Addendum No. 3

City of Coquitlam

RFP No. 25-002

Burke Mountain Athletic Park Construction Services

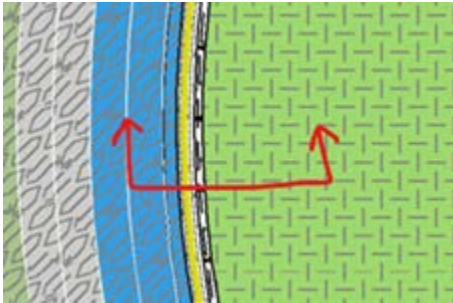
Q1. Is there any Geotech information of what the onsite existing fill material is (i.e. behind existing walls and across the site previously filled)

A1. The backfill behind the Lock-Block retaining walls consists of a 75 mm minus crushed gravel. This material was also used as backfill to achieve design grades elsewhere on site, as well as over the surface of the site. Till-like soils from the bulk excavation were also reused as fill in discrete locations.

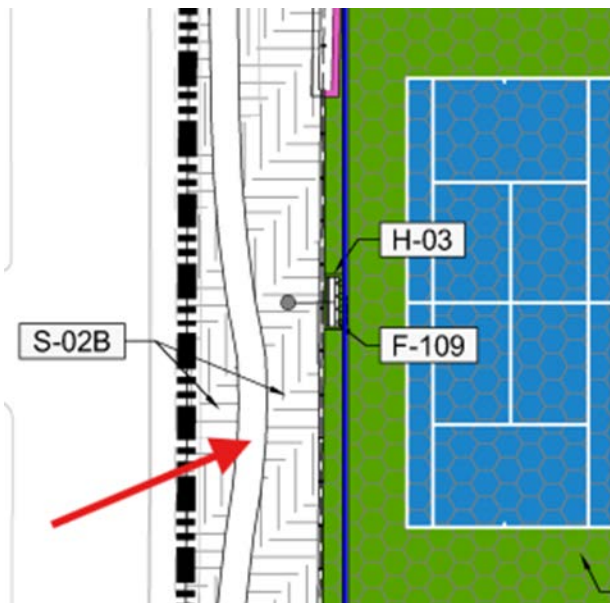
Q3. Can you provide a cross-section to cover the Rubber Track, Concrete Runnel, Fence, and Artificial Turf?

A3. Refer to VDZ's Drawing LD-08/1 Track Section Drawing

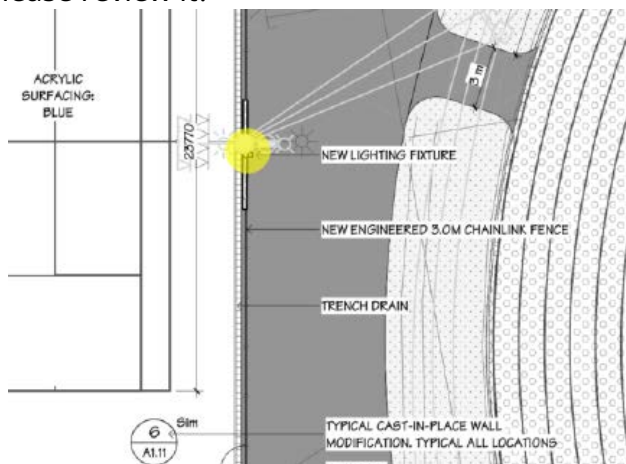
Q6. This detail seems unclear regarding the cast in place wall modification, could you please review it?

A6. The area highlighted in the question is not proposed to be modified. The cast in place wall modification areas are noted on the structural drawings, including the site plan and detail 2/S.1, and are on the west and south sides of the tennis court area.

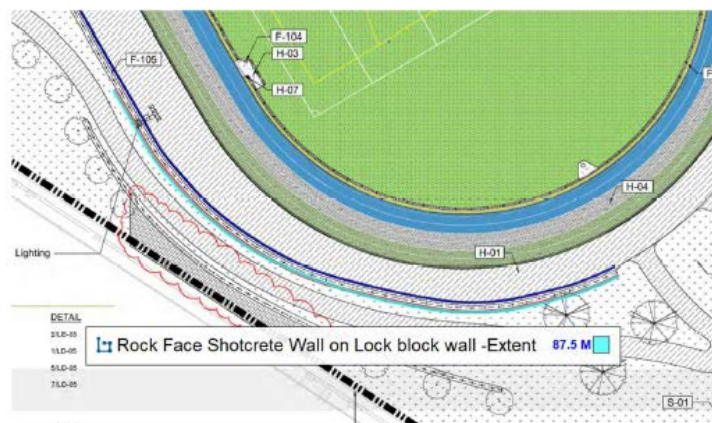
Q10. Anti-graffiti coating for Lock block wall, on addendum#1 indicate on up to 3m high, in addendum No. 2, the 3m high has been removed, for Anti-graffiti coating, it is inexpensive, but not for shotcrete surfacing, for the fairness of pricing, could you please provide area of coverage (m2 of ft2) for item I instead of Lot?

A10. Confirm unit cost and total coverage (m2) included when pricing for anti-graffiti coating for lockblock wall to allow for comparison.

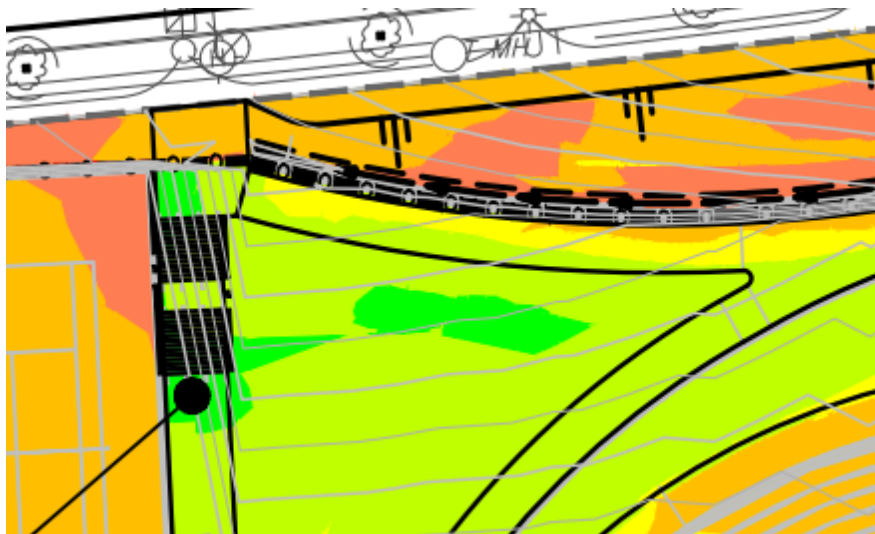
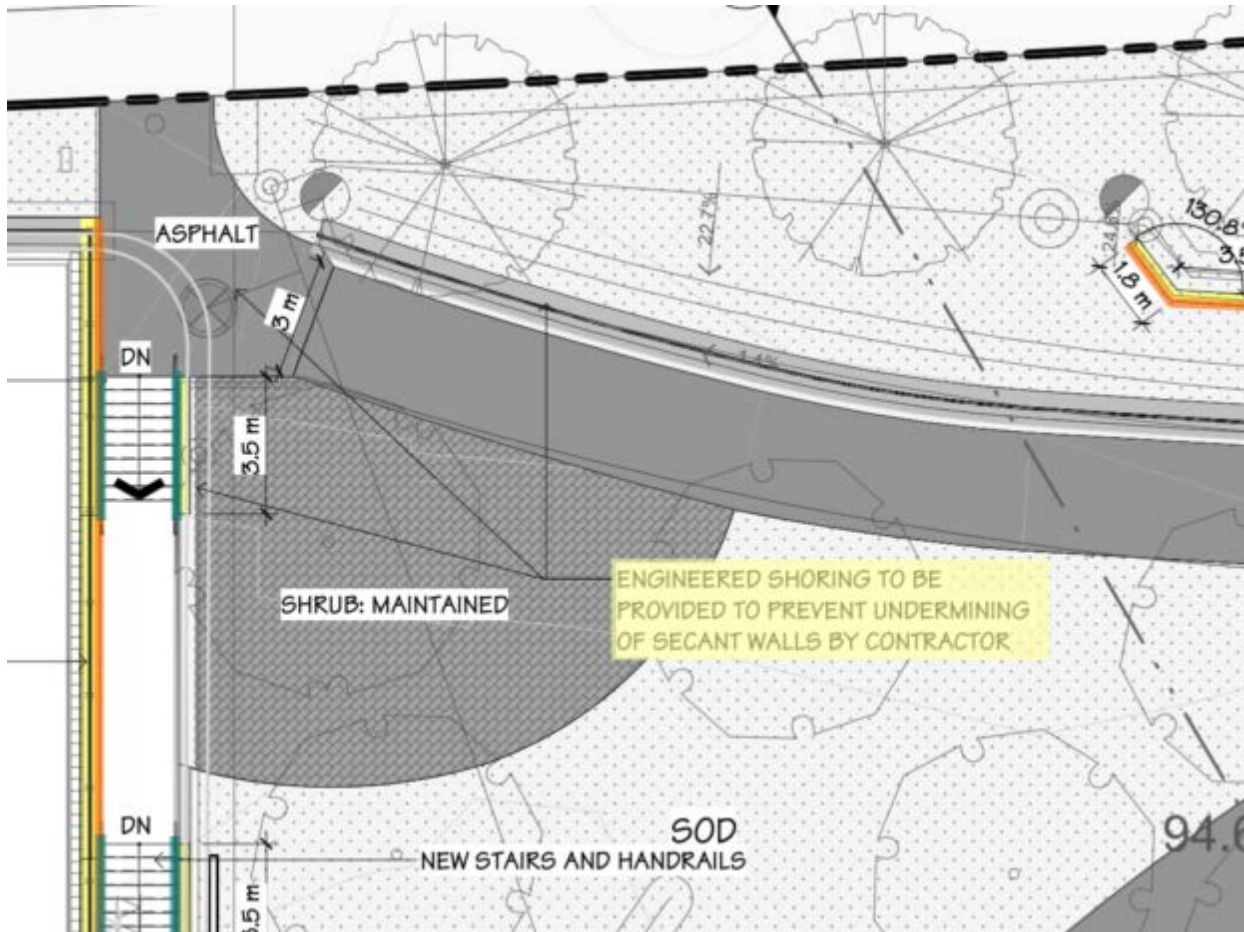
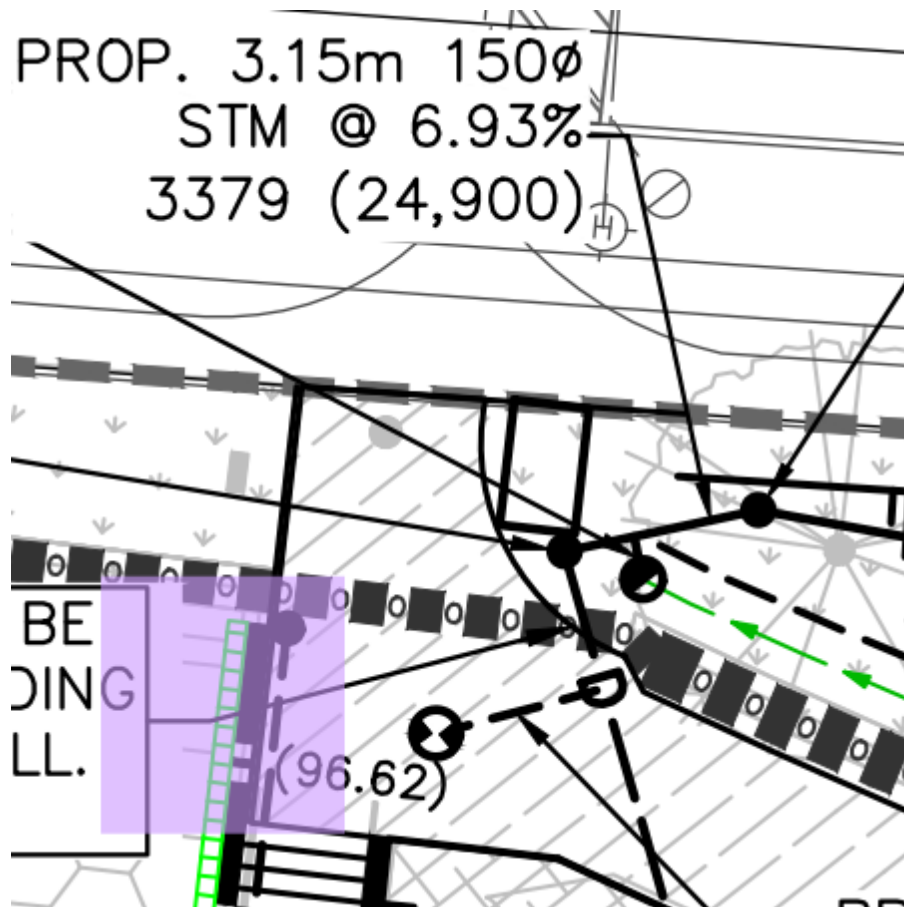
Q13. Could you please clarify if shoring is required throughout the entire area mentioned in the note, or only in specific locations such as around the concrete wall next to the tennis court and the storm installation beneath it? Also, would it be possible to mark the exact extent of the shoring on the plan for coordination?

A13. A geotechnical excavation details was included within the March 2025 geotechnical memo. Please review the geotechnical memo and attached drawings. Shoring is not needed in that area; just sloping and engineering review as discussed in the March 2025 memo.
